**SANDY BEACH NORTH DEVELOPMENT
RESPONSE TO ENVIRONMENTAL CONSTRAINTS ANALYSIS LOT 22 DP 1070182, PACIFIC
HIGHWAY, SANDY BEACH NORTH (SAINTY AND ASSOCIATES, 2006)**

SANDY SHORES DEVELOPMENTS PTY LTD

**SCIENTIFIC ASSESSMENT OF
ENTRANCE BERM ELEVATION FOR
HEARNS LAKE, SANDY BEACH NORTH**

**Issue No. 2
JANUARY 2007**

FIGURE 10

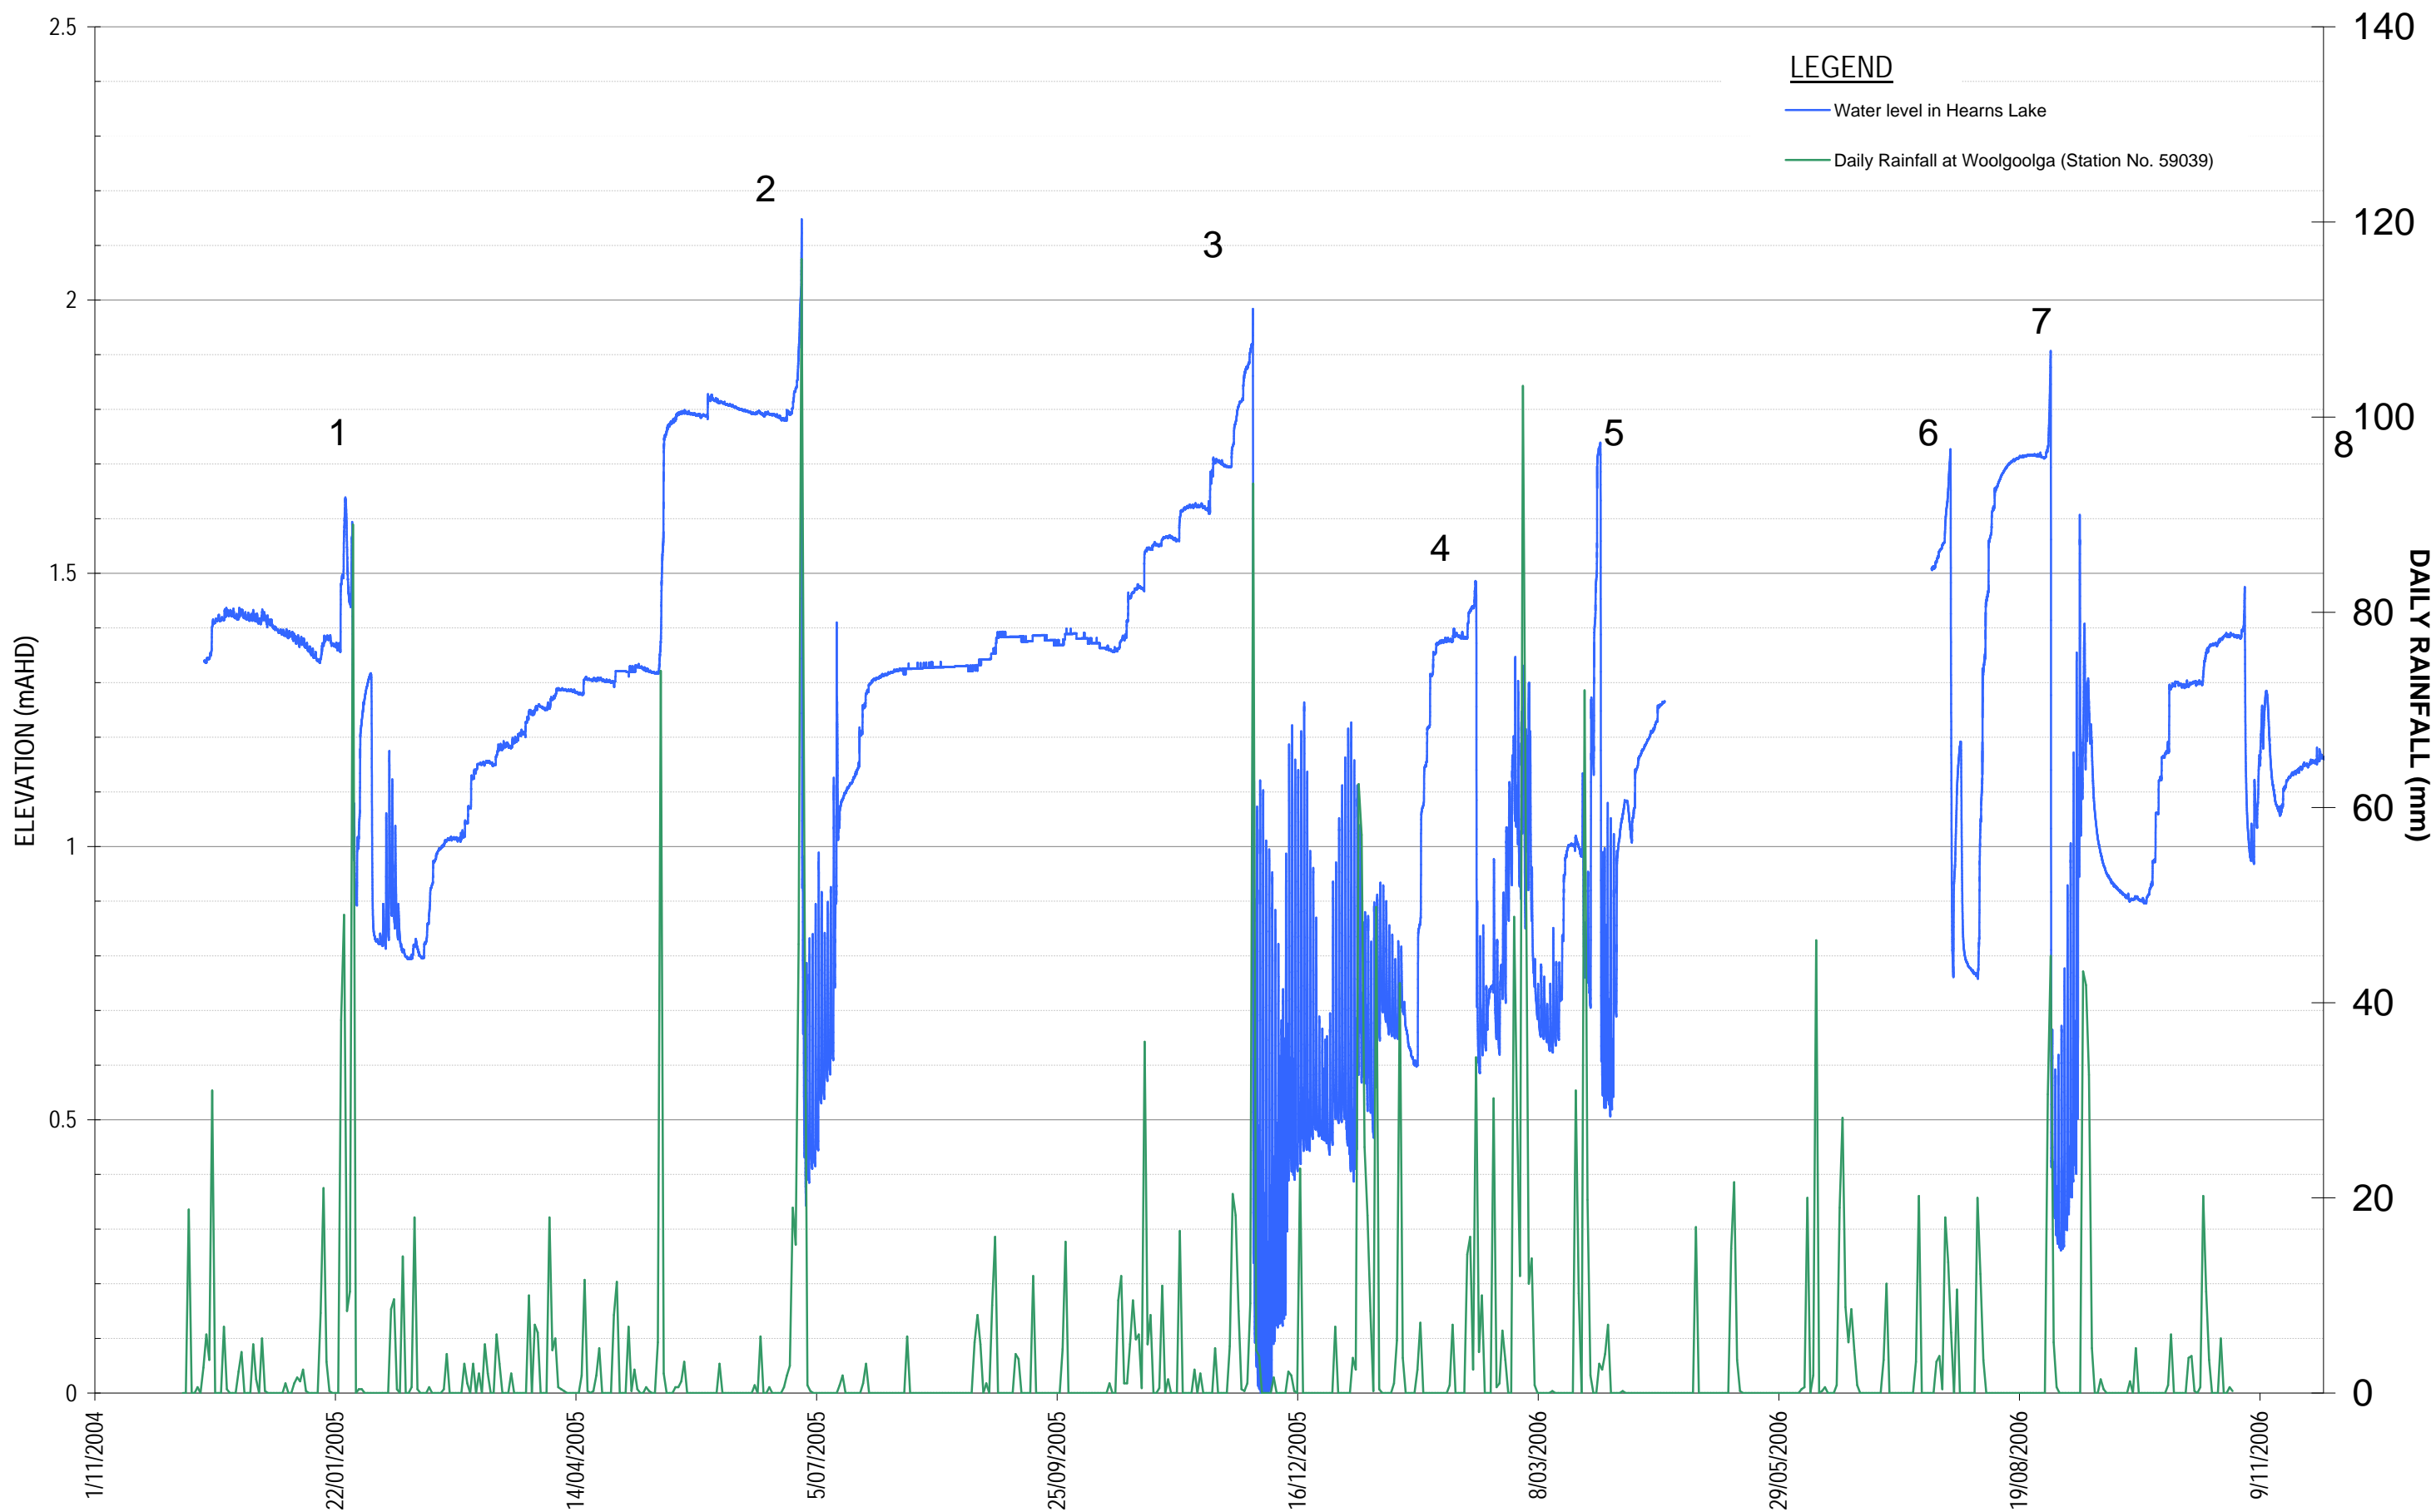
Figure 10 shows that the maximum recorded lake water level over the last 2 years was 2.15 mAHD. This occurred on 30th June 2005 and corresponded to a period of intense rainfall in which 214 mm fell in three days. More than half of this rainfall (116 mm) fell on 30th June 2005, and led to the entrance breakout reflected in the water surface profile shown in **Figure 10**.

Figure 10 shows the correlation between heavy rainfall events and entrance breakout. The rise in water level and the steepness of the profile reflects the extent and intensity of the rainfall, respectively. The subsequent fall in lake water level highlights episodes of entrance breakout followed by tidal intrusion which is evidenced by the harmonic signature in the data record.

The water surface level plot presented in **Figure 10** suggests that entrance breakout occurred on 7 occasions between December 2004 and December 2006. The dates when entrance breakout occurred and the associated rainfall are summarised in **Table 2**.

Table 2 and **Figure 10** indicate that peak lake water levels prior to entrance breakout ranged between 1.5 mAHD and 2.15 mAHD. This suggests that the entrance berm elevation over this period varied between these levels.

Therefore, the peak water level data recorded over the last two years suggest that the contemporary entrance berm elevation varies between 1.3 and 2.0 mAHD. This indicates that the average entrance berm elevation is of the same order as that determined from the photogrammetry; that is, in the order of 1.6 mAHD.

**INTERPOLATED CONTOURS
BASED ON 1943
PHOTOGRAMMETRY**

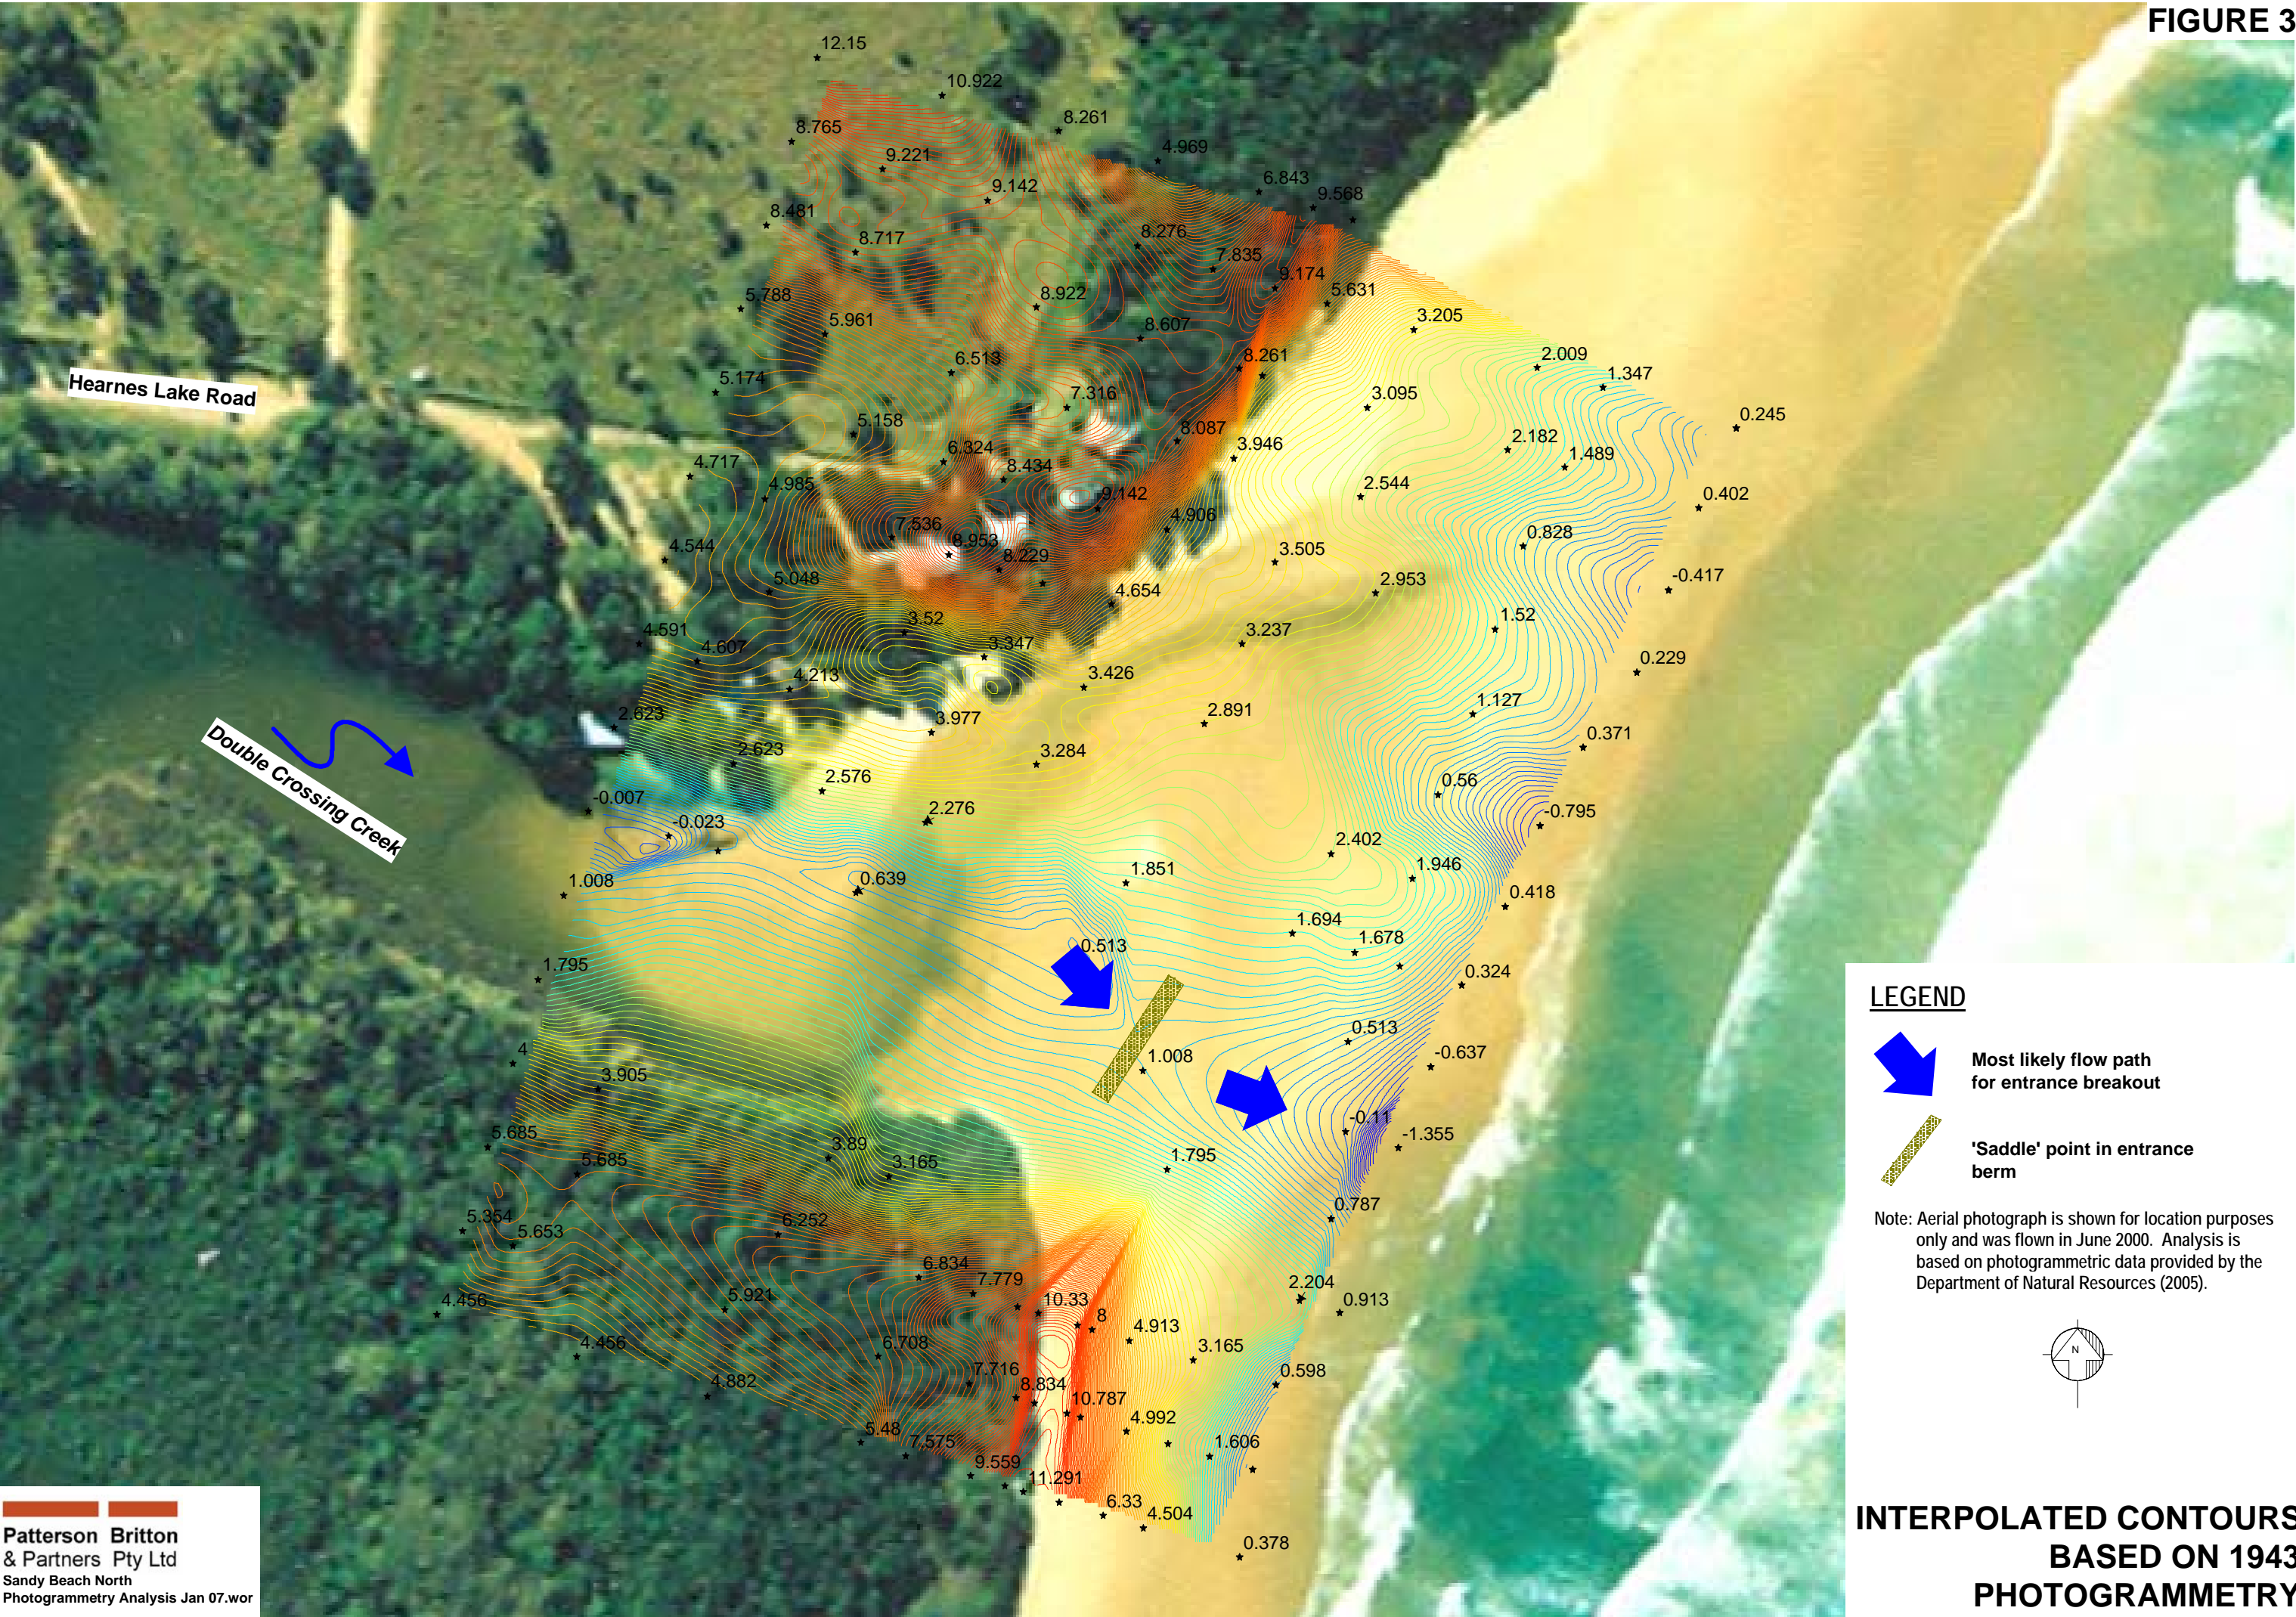
The contour plans presented in **Figures 3 to 9** identify the relict entrance channel or “saddle” through the beach berm that would form the hydraulic control for entrance breakout. The hydraulic control is defined by the level of the low point or “saddle” at the seaward end of the channel which will provide a pathway for flow connection between the lake and the ocean. The lowest of these saddles defines the controlling entrance berm elevation at the time that the aerial photograph was taken.

Each of **Figures 3 to 9** was interpreted to identify the controlling saddle in the contour maps; that is, the lowest saddle which would trigger breakout when the lake level rose due to rainfall in the catchment. The results of the analysis are summarised by the data presented in **Table 1**.

The results of the analysis indicate that over the 60 years of record, the entrance berm at the mouth of Hearns Lake had an elevation that varied between 0.1 mAHD and 2.6 mAHD. More significantly, the results indicate that the entrance berm elevation exceeded 1.6 mAHD on only one of the seven years for which photogrammetric analysis was undertaken.
